From: Bratcher, Mike, EMNRD
Sent: Monday, February 09, 2009 10:06 AM
To: 'Bob Asher'
Cc: Jerry Fanning
Subject: Below Grade Tank Closure Request

RE: Dayton EX Battery
30-015-21708
Section 21, T18S-R26E
Eddy County, New Mexico

From: Bratcher, Mike, EMNRD
Sent: Monday, July 07, 2008 7:55 AM
To: 'jerryf@ypcnm.com'; 'boba@ypcnm.com'
Cc: Gum, Tim, EMNRD
Subject: Below Grade Tank Closure Requests

Pit or Below-Grade Tank Registration or Closure

EXHIBIT
Sample Diagram (Not to Scale)

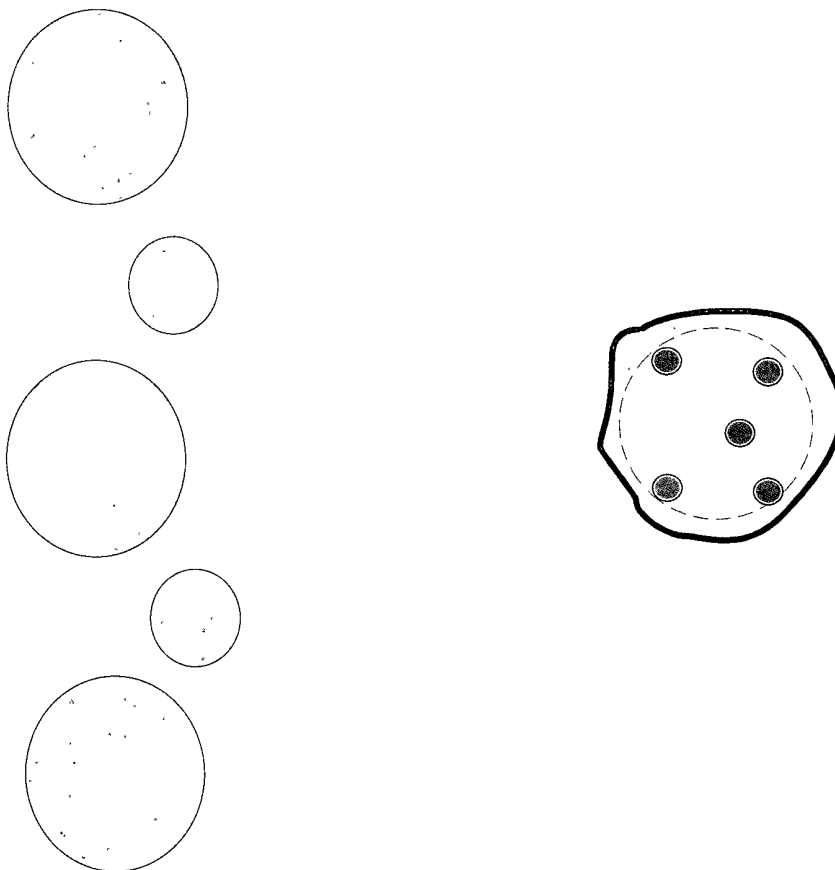
Additional delineation sampling has been performed, enclosed are analytical results that indicate decreasing levels on chlorides. Yates Petroleum Corporation requests closure of the below grade tank site. The analytical results for BTEX and TPH are within the RRAL's for BTEX is 50 ppm and TPH is 1000 ppm with a Total Ranking Score of ten (10). Yates Petroleum Corporation requests closure of the below grade tank site.

The sites listed have had below grade tank/tanks removed. Based on documents and analytical data provided by Yates Petroleum, the request to close and backfill the sites is approved.

EXHIBIT
Sample Diagram (Not to Scale)

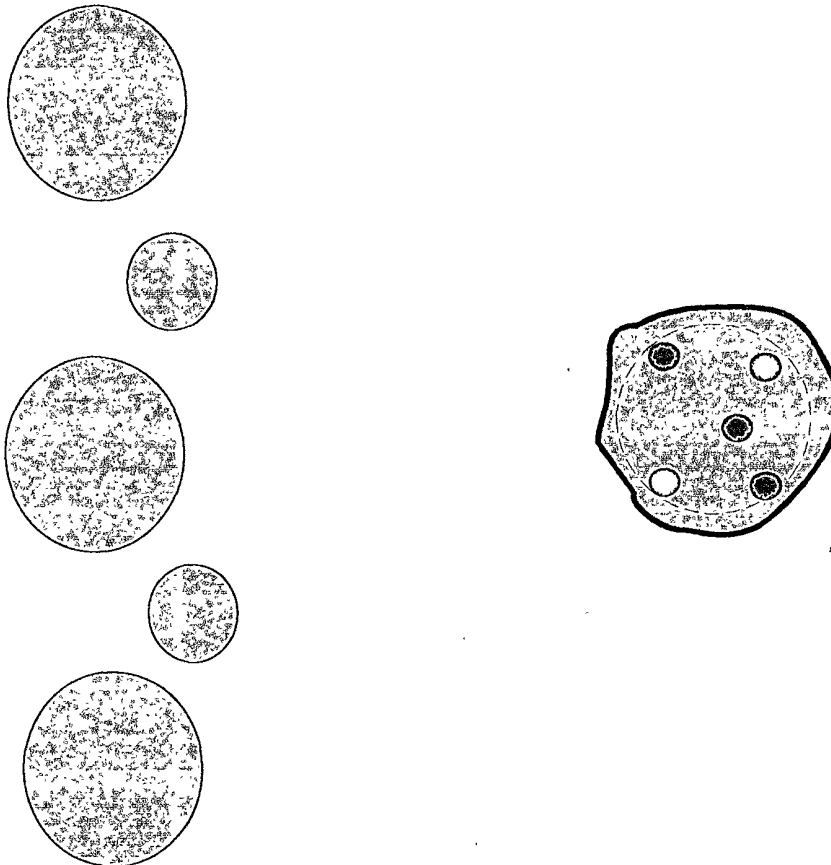
DENIED

DENIED

EADS GA Btry	30-015-21788	N-22-18-26	Chloride contamination level increase in bottom samples at 1' to 2' depth. Additional samples required to delineate contamination.
Flint GU 001 Btry	30-015-21933	J-22-18-26	Chloride contamination level increase in bottom samples at 1' to 2' depth. Additional samples required to delineate contamination.
			Removal of 1' of material as proposed is approved to address hydrocarbon contamination.
Len Mayers 001	30-015-05926	D-28-18-26	Chloride contamination level increase in bottom samples at 1' to 2' depth. Additional samples required to delineate contamination.
Gates AAC Btry	30-015-24931	C-22-18-26	Chloride contamination level increase in bottom samples at 1' to 2' depth. Additional samples required to delineate contamination.
Cannon FW Btry	30-015-21775	C-21-18-26	Chloride contamination level increase in bottom samples at 1' to 2' depth. Additional samples required to delineate contamination.
